# SERVICE BULLETIN

## TAILBOOM ASSEMBLY ATTACH FITTING ONE TIME INSPECTION AND REPAIR

Model 600N Helicopters, serial number RN003 thru RN063.

Tailboom Attach Fitting (P/N 500N3422), Angle (P/N 500N3429-6), Clip (P/N 500N3427-7).

**Figure 1. Tailboom Attach Fitting and Angle Inspection**

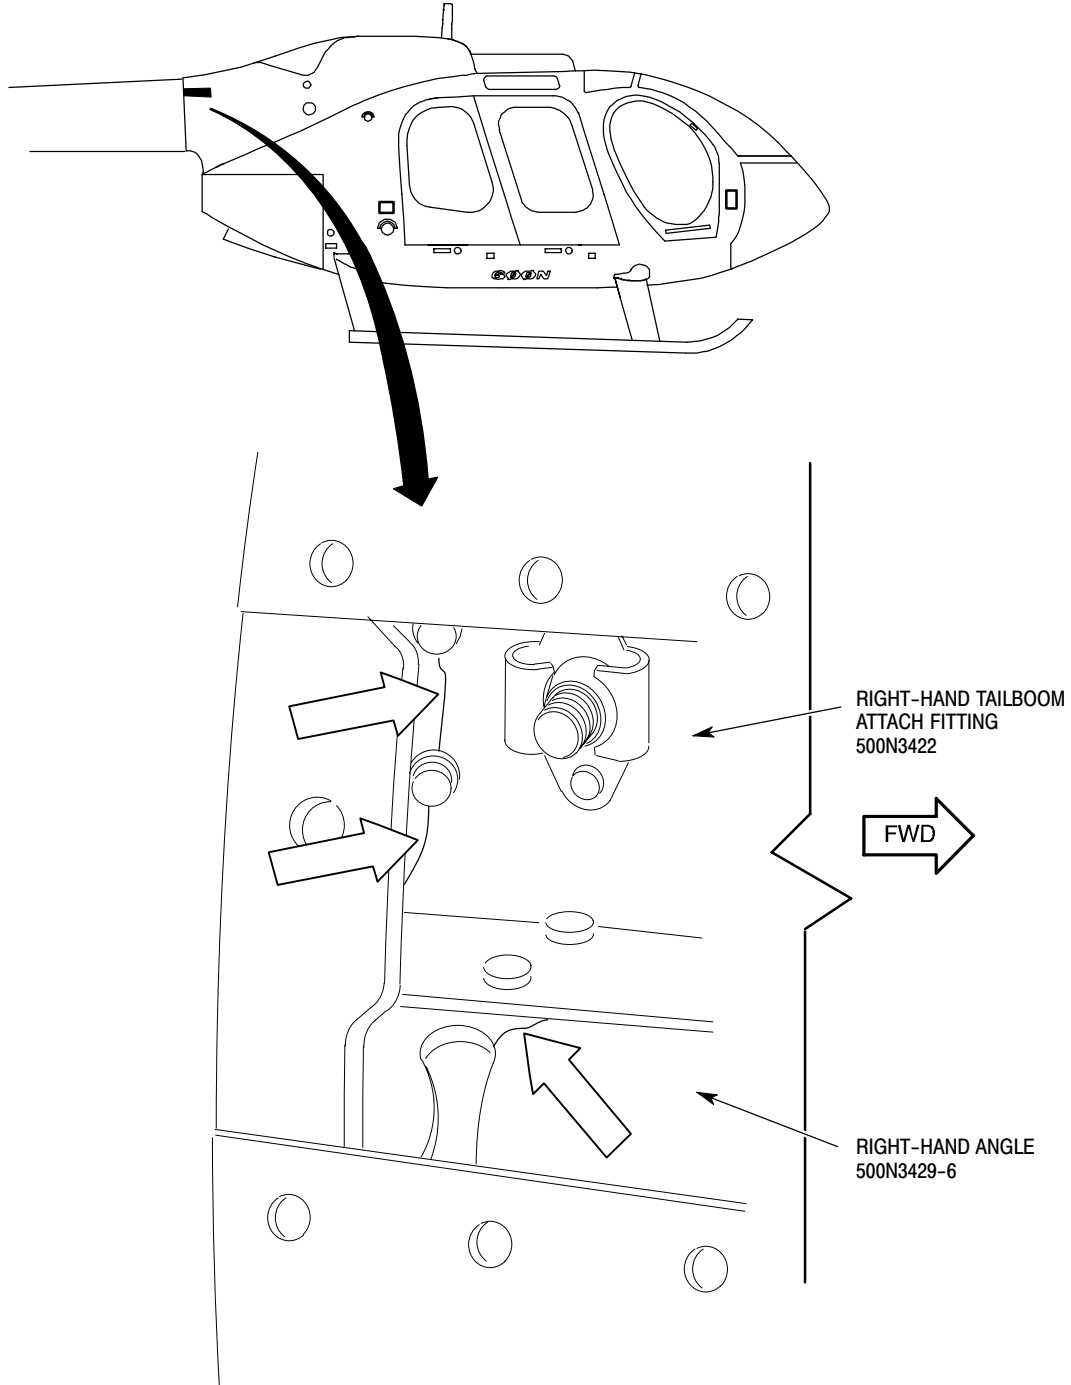
- (2). Drill out rivets attaching **upper** left-hand and right-hand access covers.  
(Ref. Figure 1)
- (3). Inspect upper left-hand and right-hand tailboom attach fittings.

- (a). Using 10X magnification and bright light inspect for cracks. Pay particular attention to area around aft rivet holes. No cracks are allowed.
  - (b). If any cracks are found, contact MDHI Field Service Dept. for replacement instructions.

**Figure 2. Clip Installation**

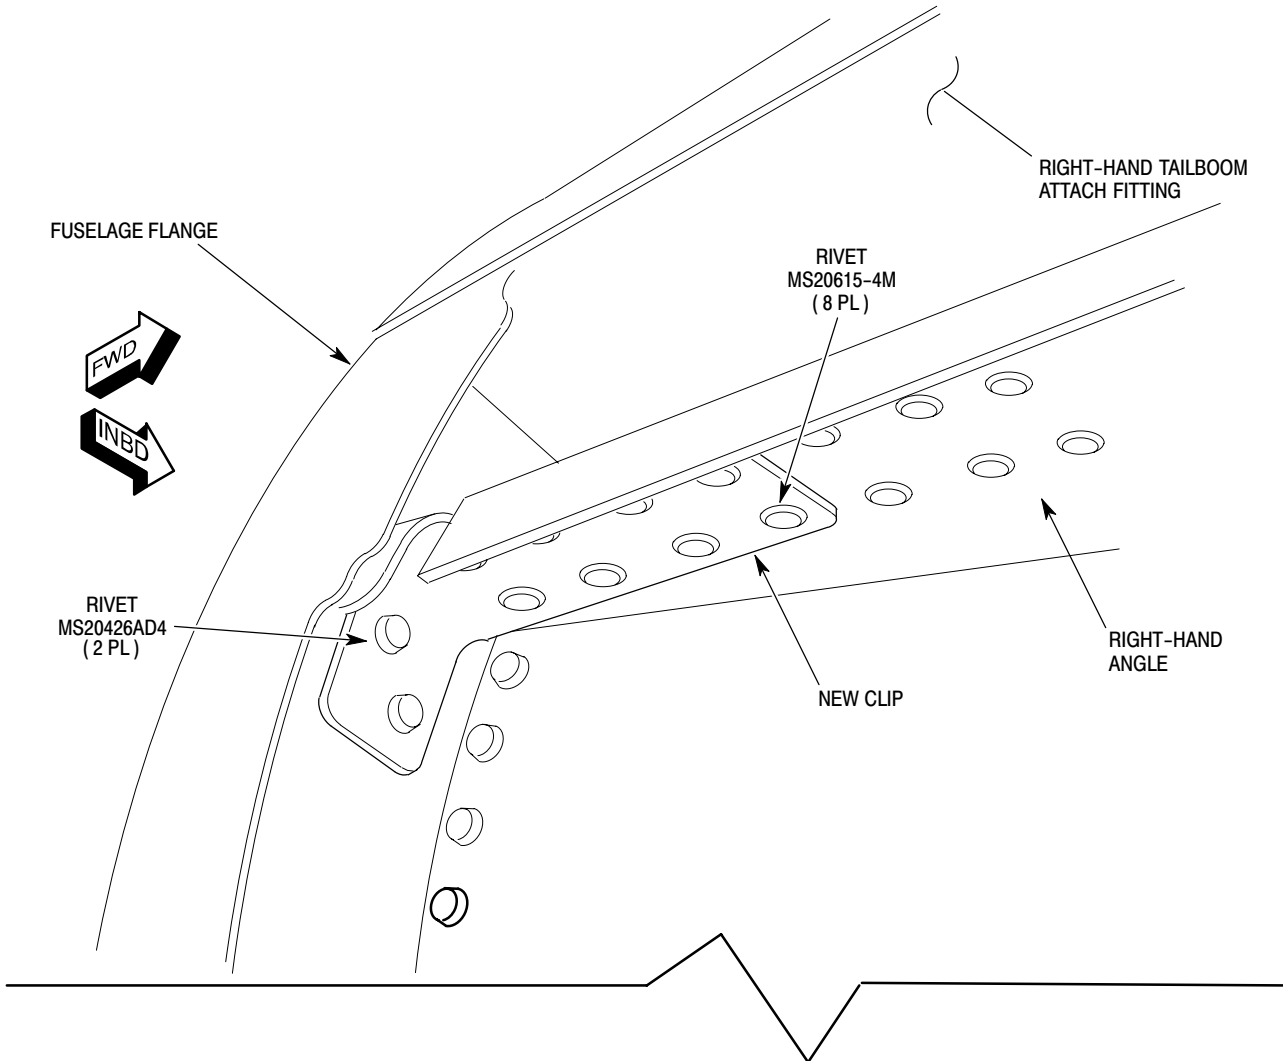
- (c). If any cracks are found on right-hand angle, proceed as follows:

- 1). Drill out top three rows of rivets (six rivets) securing outer skin below tailboom attach fitting and pull skin to access angle.
- 2). Drill out rivets securing clip to angle and tailboom attach fuselage flange. Remove clip.
- 3). Fabricate new clip from 301 1/4 hard stainless steel, as shown. (Ref. Figure 3).
- 4). Install new clip with two (2) MS20426AD4 and eight (8) MS20615-4M rivets. Install rivets wet with primer. (Ref. Figure 2).

**Figure 4. Modification of Access Panels**

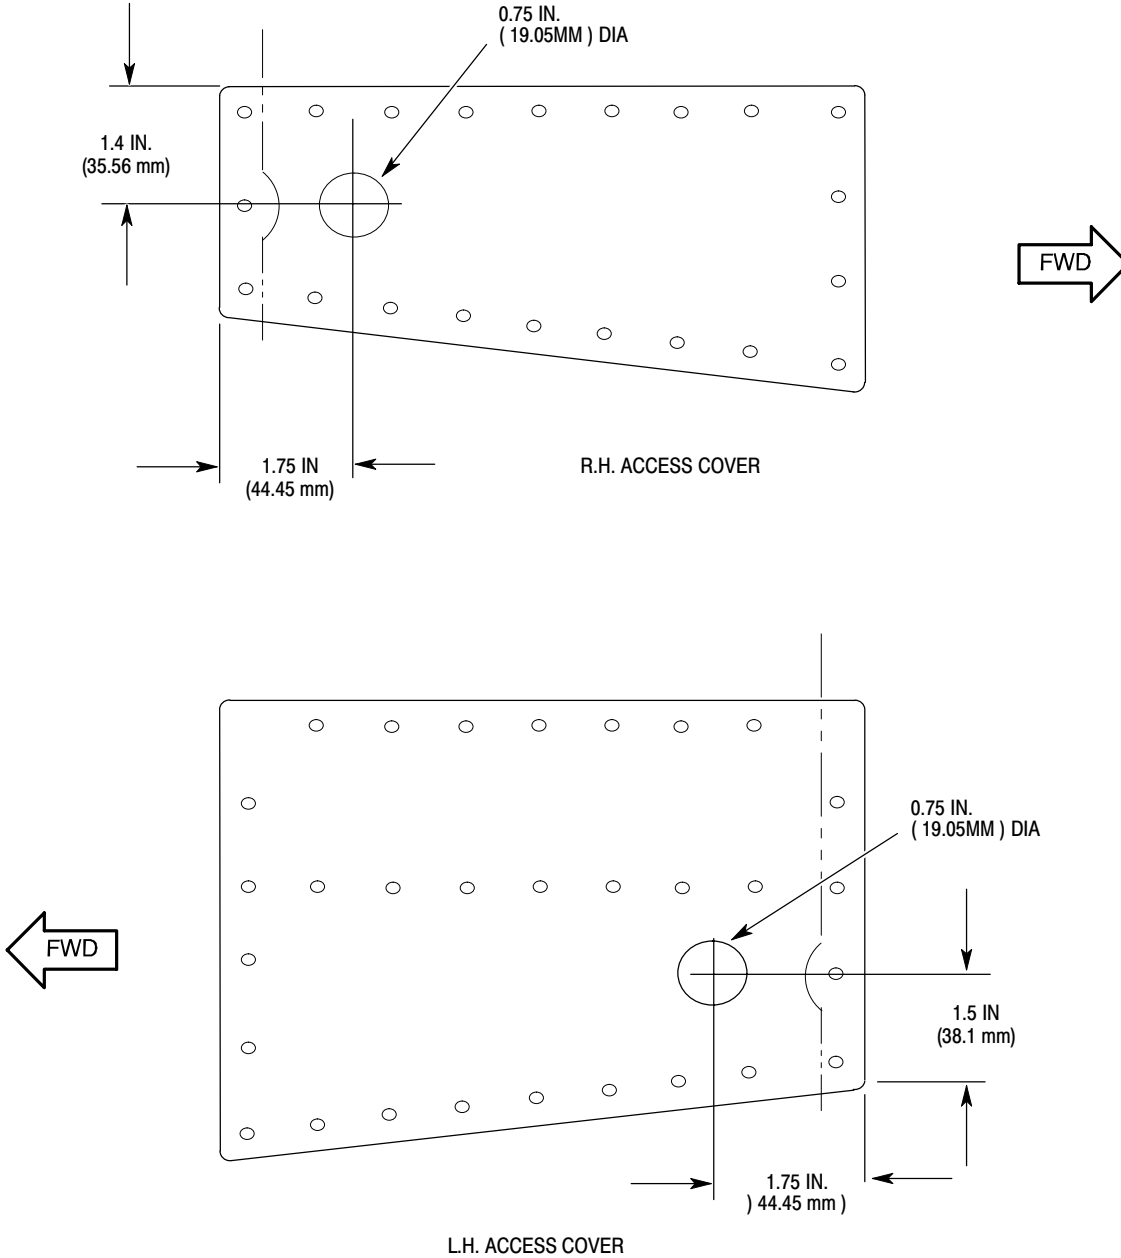
- (6). Modify left-hand and right-hand access covers.
  - (a). Locate, drill and deburr 0.75 inch (19.05 mm) hole in each cover as shown.
  - (b). Install plug button in hole and seal with sealing compound.
- (7). Remove all debris and close outer skin using blind rivets.
- (8). Install modified left-hand and right-hand access covers with blind rivets.
- (9). Install tailboom (Ref. CSP-HMI-2, Section 53-30-40, Tailboom Installation) except add one washer to each tailboom bolt between tailboom and NAS1587 countersunk washer. Ensure that minimum of two threads extend past nutplate.
- (10). Using a 0.002 inch feeler gauge, check for gap between tailboom and fuselage flange within 0.60 inch (15.3 mm) of centerline of each of the four attach bolts.1 No gap allowed. If gap exists, contact MDHI Field Service Dept.
- (11). Install tailboom fairing
